Access Compliance Report

Public Rights-of-Way

(Curb Ramps)

Intersection ID: 46145	Main Street: ARBOR_CREEK_DR	Cross Street: ARBOR_DAY_CT	Location: NE
ADA ID: DDE40DECE521	Ramp Type: BlendTrans1	Initial Pass/Fail: Pass	Overall Compliance: No
Severity Score: 0			
Codes/Mitigation Info/Possible Solution		Field Measurements/Component Compliance

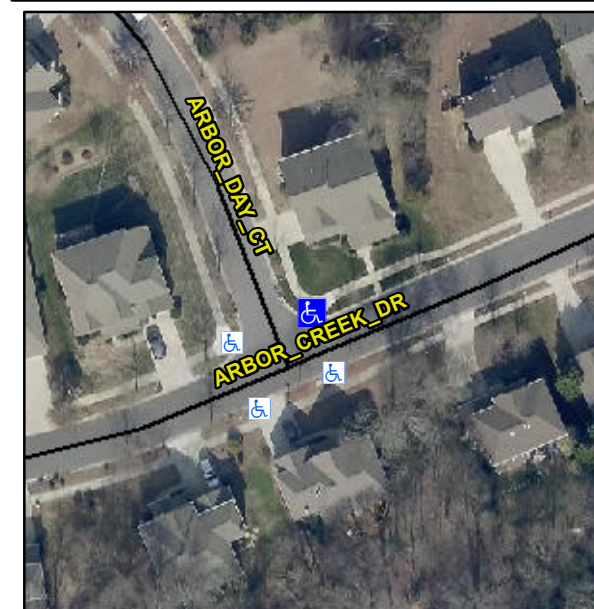
R304.2.2-Perp, R304.3.2-Para, R304.5.3, R305.2

Compliance	Description	Data	Compliance	Description	Data
N/A	Ramp Length (in)	57.0	Yes	BlendTrans Slope (%)	4.0
Yes	Ramp Width (in)	48.0	Yes	BlendTrans XSlope (%)	1.4
N/A	Flare Type LT	Sloped	N/A	Flare Type RT	Sloped
N/A	Flare Slope LT (%)	6.9	N/A	Flare Slope RT (%)	1.2
N/A	Flare Traversable LT?	No	N/A	Flare Traversable RT?	No
Yes	Landing Length (in)	72.0	Yes	DWS Provided?	Yes
Yes	Landing Width (in)	72.0	Yes	DWS Contrast?	Yes
No	Landing Slope (%)	2.9	Yes	DWS Length (in)	25.5
No	Landing X Slope (%)	2.6	Yes	DWS Full Width?	Yes
N/A	Landing Curb? (Y/N)	No	No	DWS Offset (in)	2.5
N/A	Shared Landing?	No			
Yes	Gutter Ponding?	No	Yes	Gutter Slope (%)	1.8
Yes	Gutter Lip Ht (in)	0.0	Yes	Gutter X Slope (%)	1.2
N/A	Painted X Walk1?	No	N/A	Painted X Walk2?	No
	X Walk 1 Direction	To W		X Walk 2 Direction	To S
	X Walk 1 Width (in)	N/A		X Walk 2 Width (in)	N/A
	X Walk 1 Slope (%)	1.7		X Walk 2 Slope (%)	1.8
	X Walk 1 X Slope (%)	2.9		X Walk 2 X Slope (%)	1.6

N/A	Ramp inside XWalk1?	N/A	N/A	Ramp inside XWalk2?	N/A
	Road Slope (%)	1.8		Clear Space?	Yes
	Road X Slope (%)	3.9	N/A	Clear Space to XWalk (in)	N/A
Yes	Any Obstructions?	No	Yes	Storm Grate/Utility Hazard?	No
	Obstruction Type			Storm Grate/Utility Type	
		N/A			N/A
			Yes	Surface Condition? (G/P)	Good
			Yes	Curb Slope (%)	5.0

Remove & Replace Curb Ramp With Two New Directional Ramps or Equivalent.
